Interactive comment on “Water resources in the Badain Jaran Desert, China: New insight from isotopes” by Xiujie Wu et al.

Xiujie Wu et al.

Received and published: 27 May 2017

Fig. 1. Figure 1: Maps showing location of the Badain Jaran Desert (A), the Badain lake sampling area (B) and the Sumu Jaran lake sampling area (C). W34 in (A) is sampling site of Gates et al. (2008a).

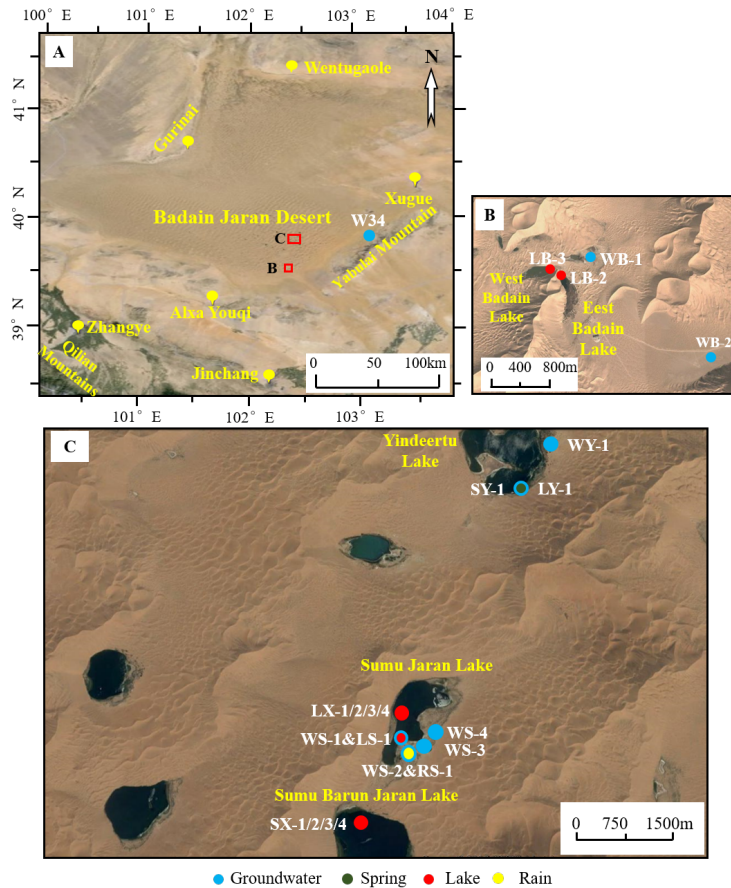
Figures and Tables: Figure 1. Please include location of GNIP station Zhanye in Fig. 1A) Reply: Accept. (see Page 18)

Fig. 2. Figure 2: Schematic diagram showing the cross-section profile between the Sumu Jaran Lake and the Sumu Baran Jaran Lake as well as the water sampling points (A) and the groundwater flow direction (B)

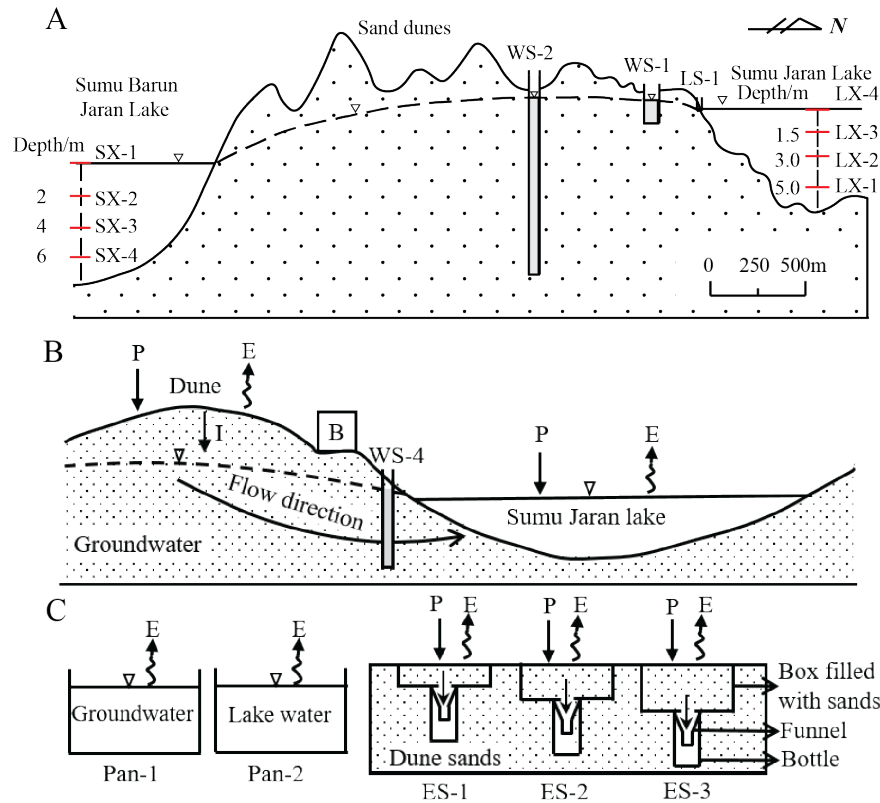
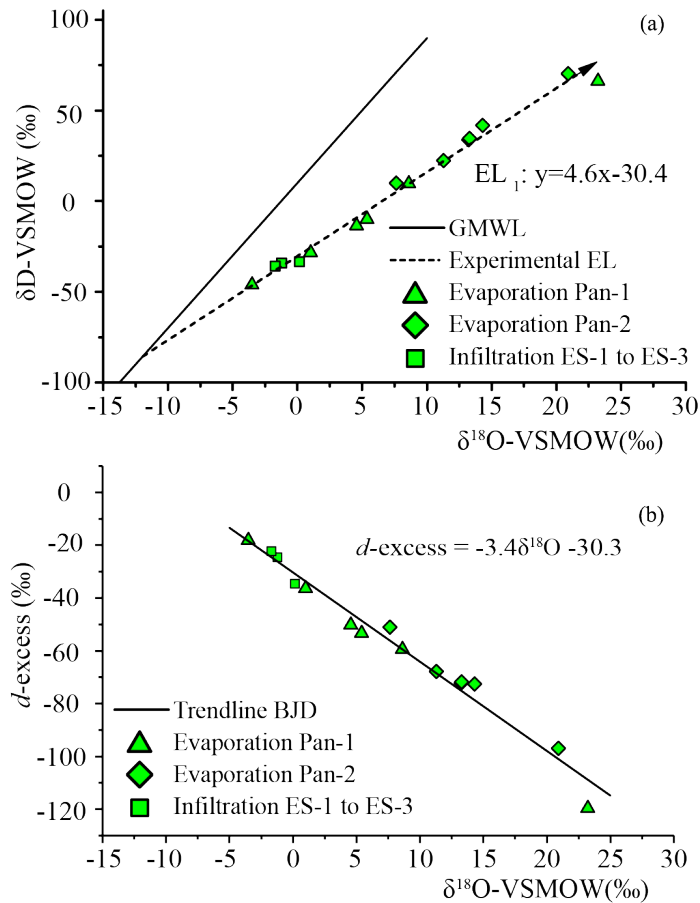
Figures 2 and 3 could be merged together Reply: Accept. (see Page 19)

Fig. 5. Figure 5: The plot of δD vs $\delta^{18}O$ values (a) and $d\text{-excess}$ vs $\delta^{18}O$ values (b) of groundwater and lake water samples from the BJD (red symbols), including new data from his study and previously published

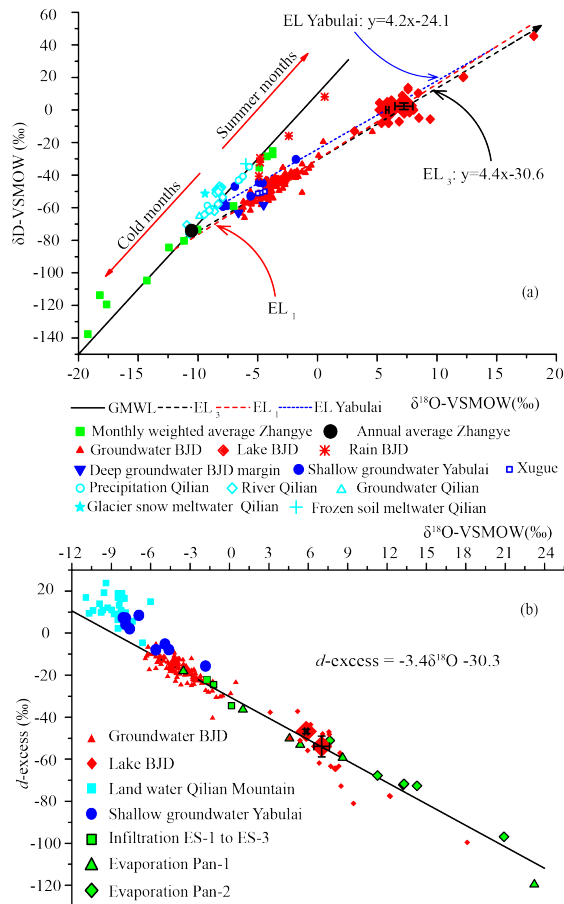
Figure 6: The two diamond dots are not clearly visible, not visible in 6b. “Land water” should be rephrased! Soil water? Reply: Accept. We use two larger diamonds than the other ones to make the error bar of the dots more clearly. (see Page 22) It is explained in the figure caption. (see Page 22, Line 8-10) land water including groundwater (Li et al., 2016), rivers (average for each river) (Chen et al., 2012; Li et al., 2016), glacier snow melt water and frozen soil melt water (Li et al., 2016)

Figure caption Figure 5: delete space between d18 and O. Reply: Accept. Figure caption Figure 6: Please correct figure caption (e.g., d18O). Reply: Accept.

Fig. 6. Figure 6: The conceptual model of the d-excess changing routines in the BJD. E represents evaporation.

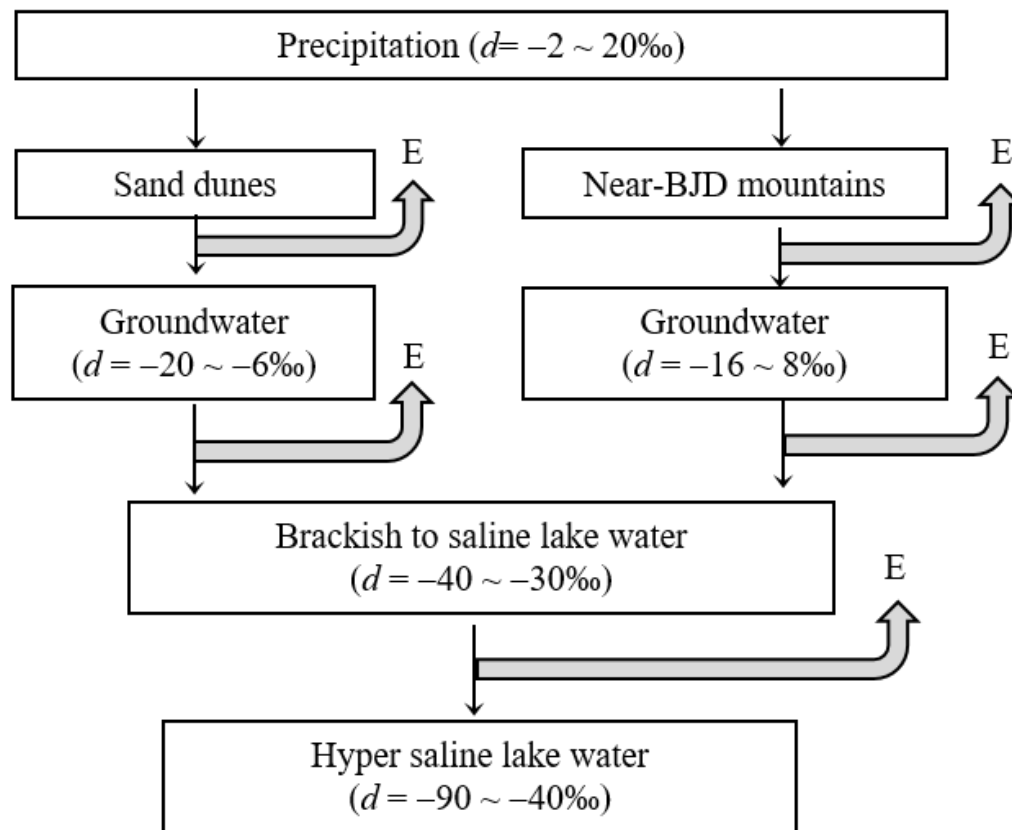
Figure 7: E – fluxes are misleading! Evaporation from groundwater to lake water fluxes could be better placed at boxes. Reply: Accept. (see Page 23) Table 1: d-excess values without digit. Reply: Accept. Table 2: Category should be rephrased into type. EC is given in mS not Ms! d18O and d2H measured against VSMOW. d-excess values without digit. Reply: Accept. Table 3: Temperature without digits or consistently. d13C against VPDB. Reply: Accept.
